Earthquake Ready Burnside Bridge:  
Combined Final Environmental Impact Statement/Record of Decision

## Draft EIS Errata

Table 2-1. Draft EIS Narrative Errata

Section 3.4.1  
(page 3-56)

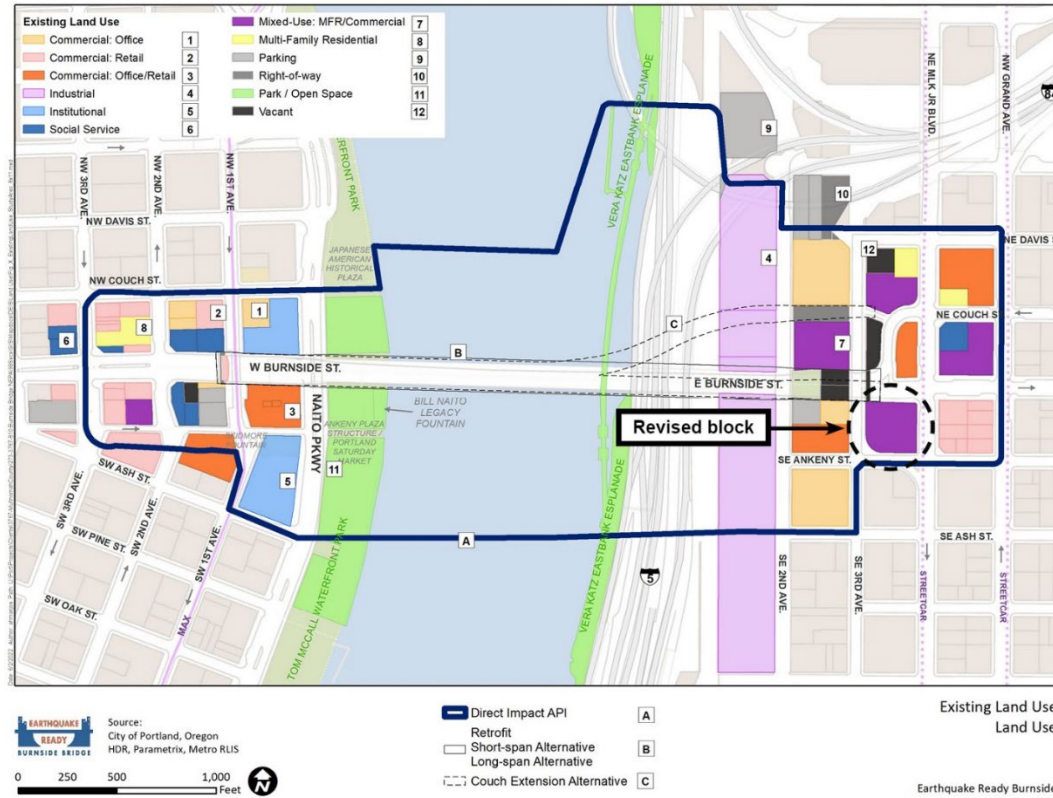
Revised the status of the block southeast of the intersection at Burnside and SE 3rd from Vacant to Mixed-Use: MFR/Commercial.

Section 3.4.1  
(page 3-57)

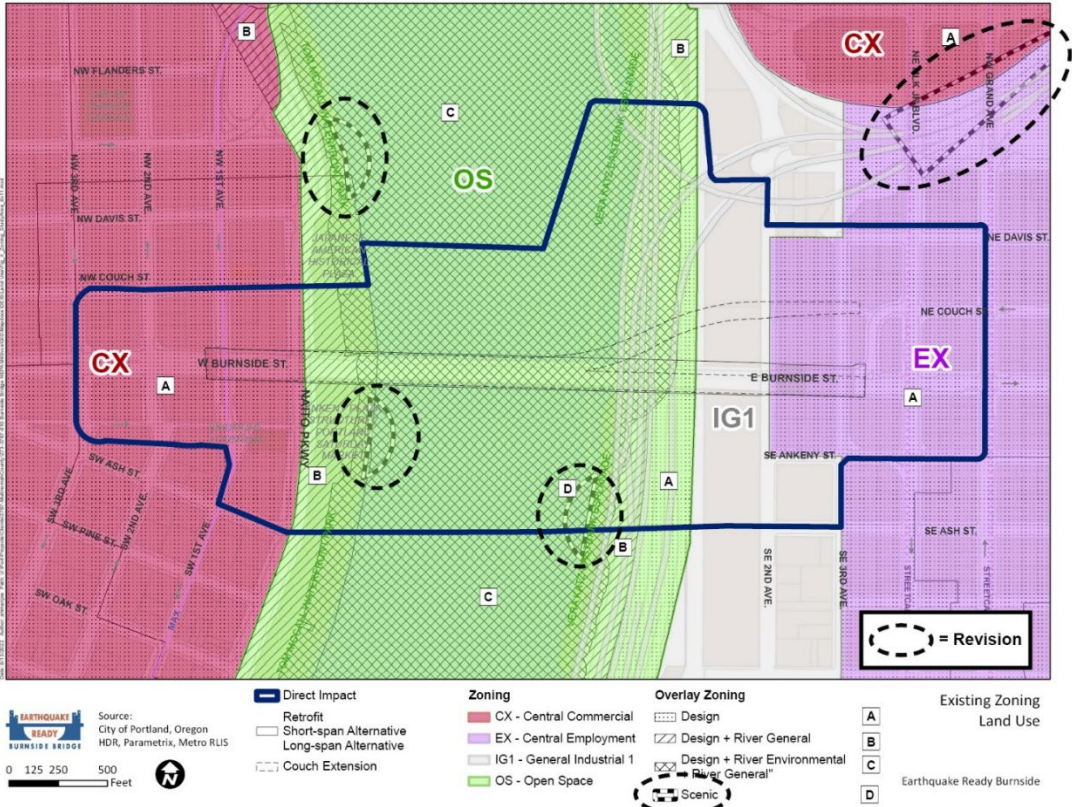
Revised to include  
Scenic Overlay Zoning.

Section 3.4.4  
(page 3-64)

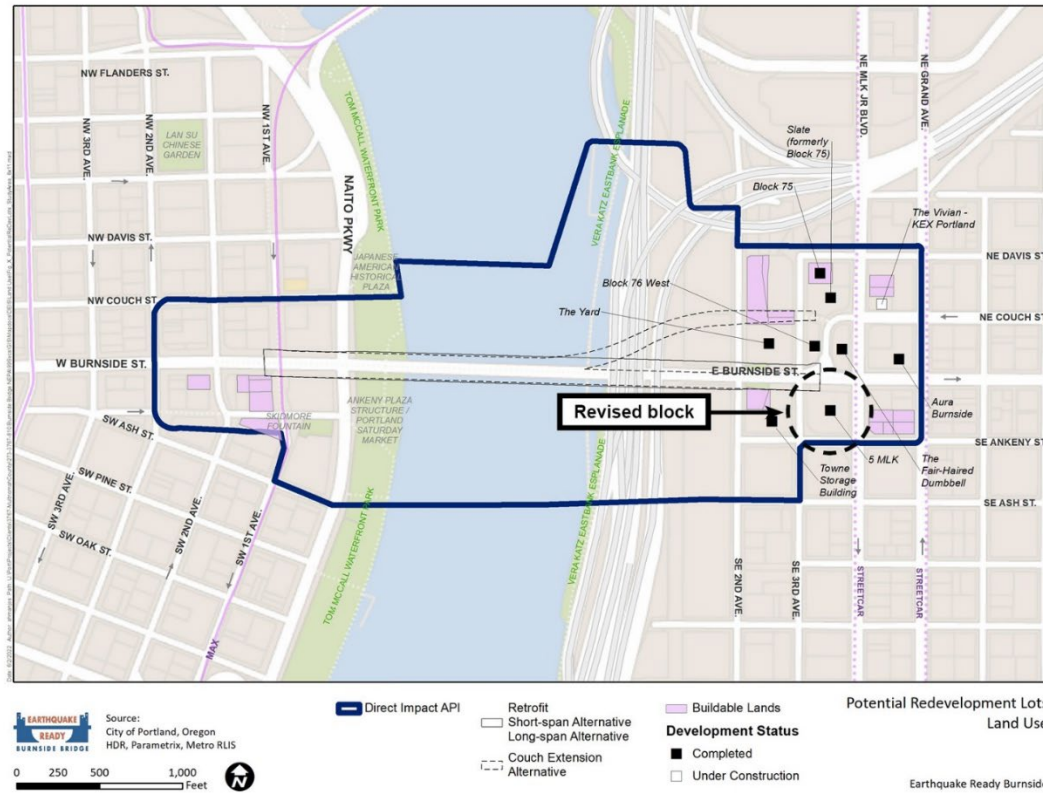
Revised the status of 5 MLK southeast of the intersection at Burnside and SE 3rd from Under Construction to Completed.

Section 3.8.1  
(page 3-94)

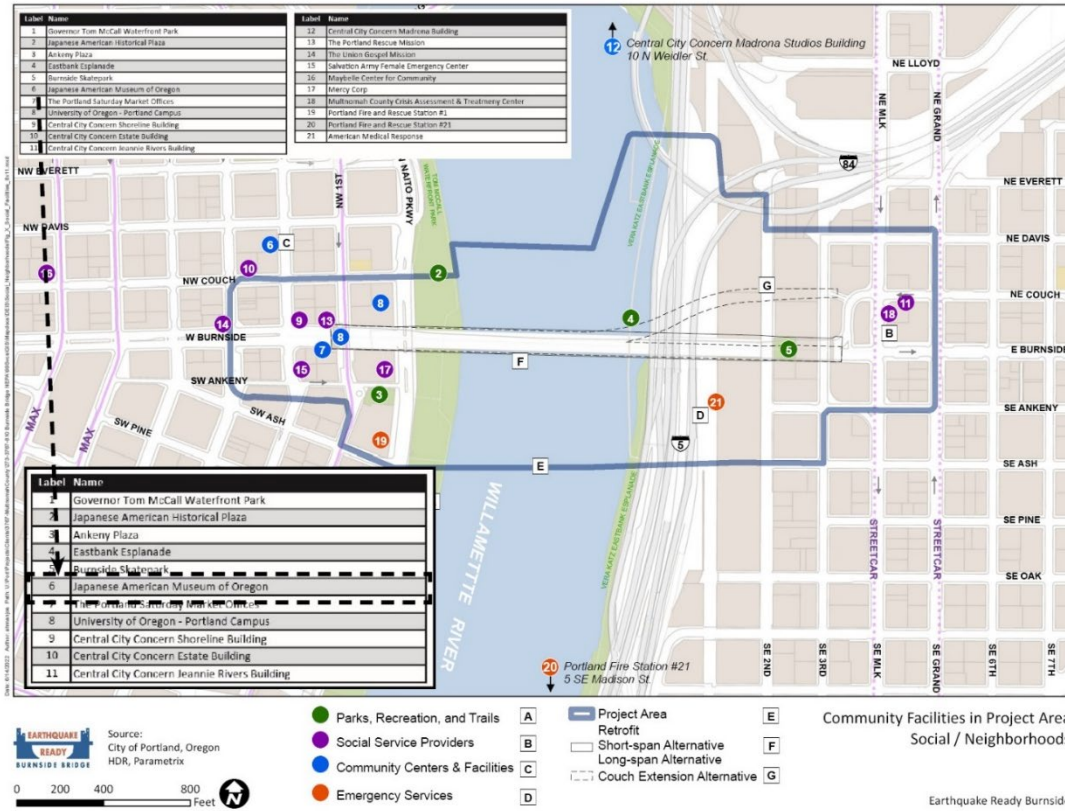
Revised item 6 in the key from The Oregon Nikkei Legacy Center to Japanese American Museum of Oregon.

Section 3.10.2  
(page 3-128)

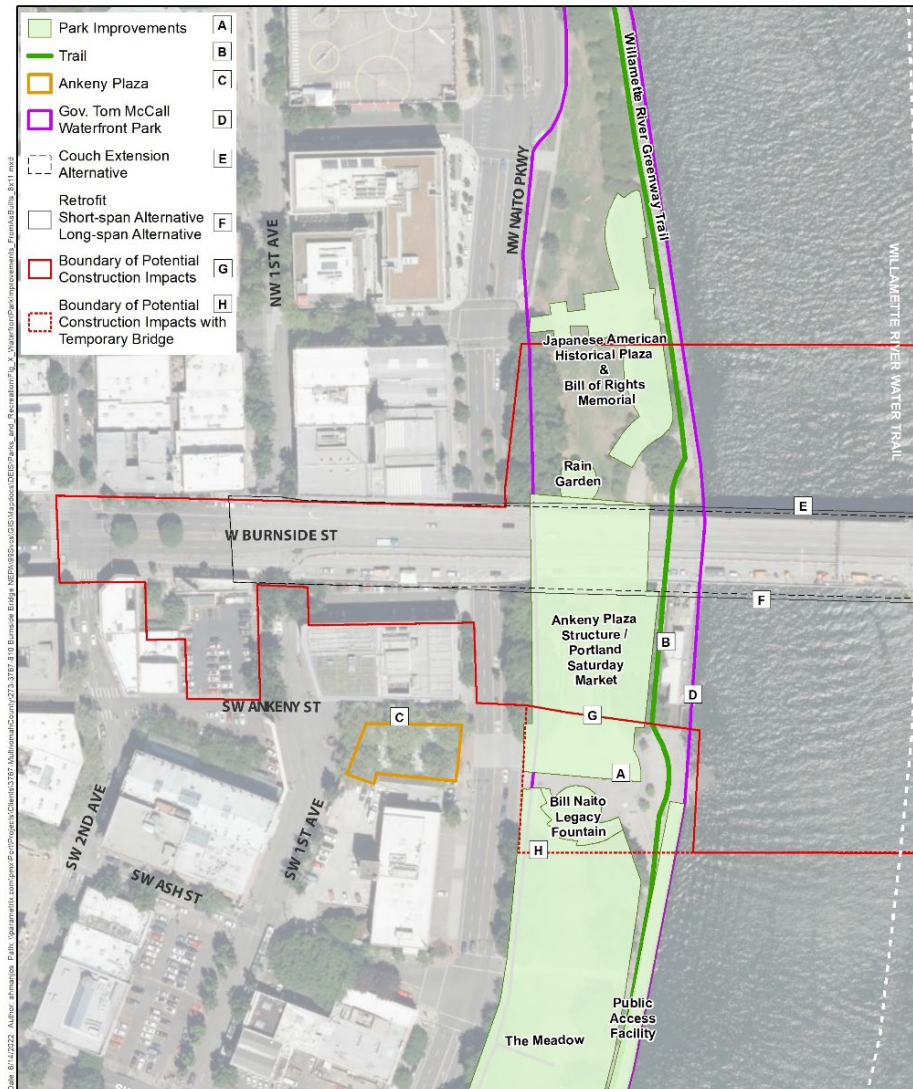
Added the Boundary of Potential Construction Impacts and the Boundary of Potential Construction Impacts with Temporary Bridge indicators; removed Direct API indicators.

Section 3.10.2  
(page 3-129)

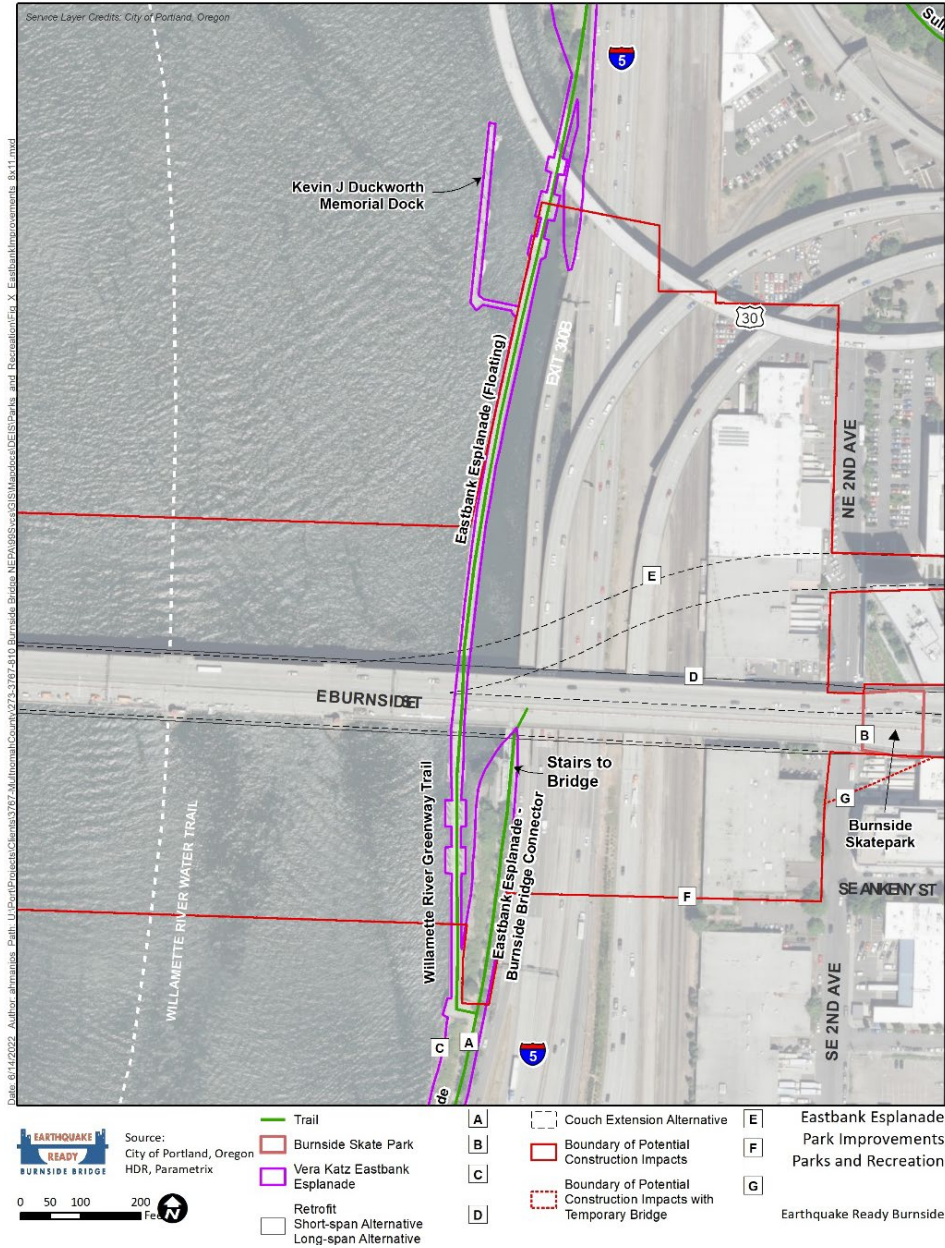
Added the Boundary of Potential Construction Impacts and the Boundary of Potential Construction Impacts with Temporary Bridge indicators; removed Direct API indicators.

Section 3.16.1  
(page 3-193)

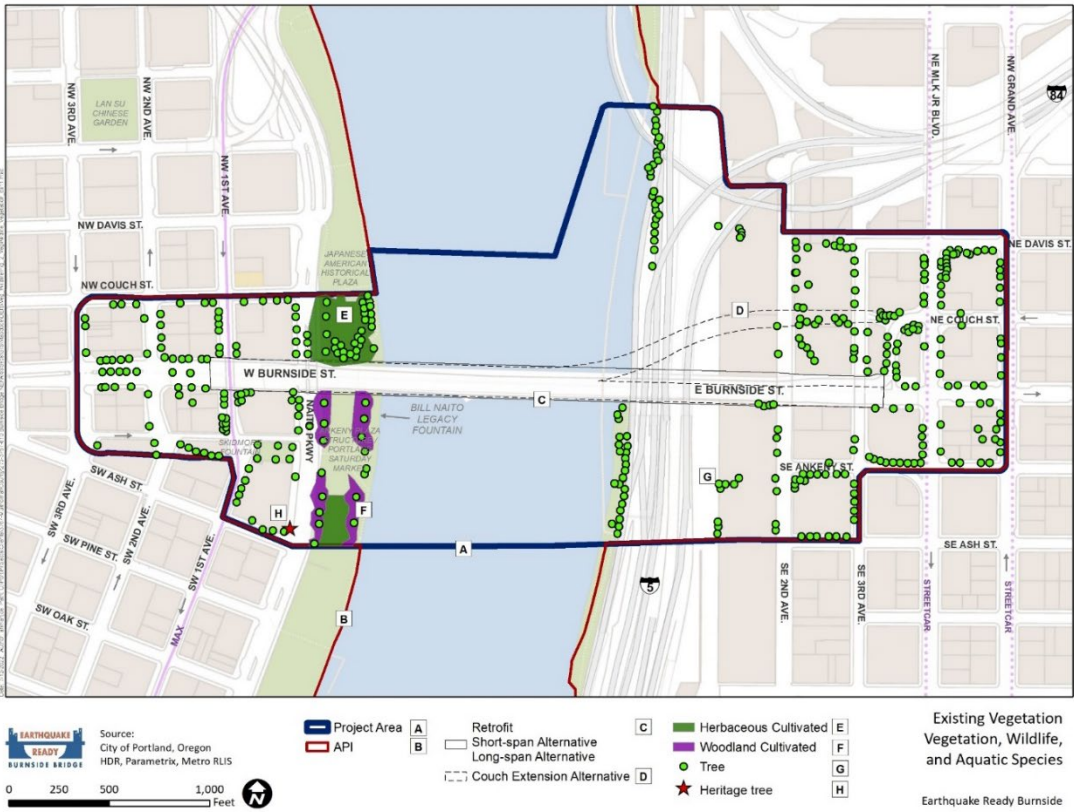
Revised to change the number of trees shown.
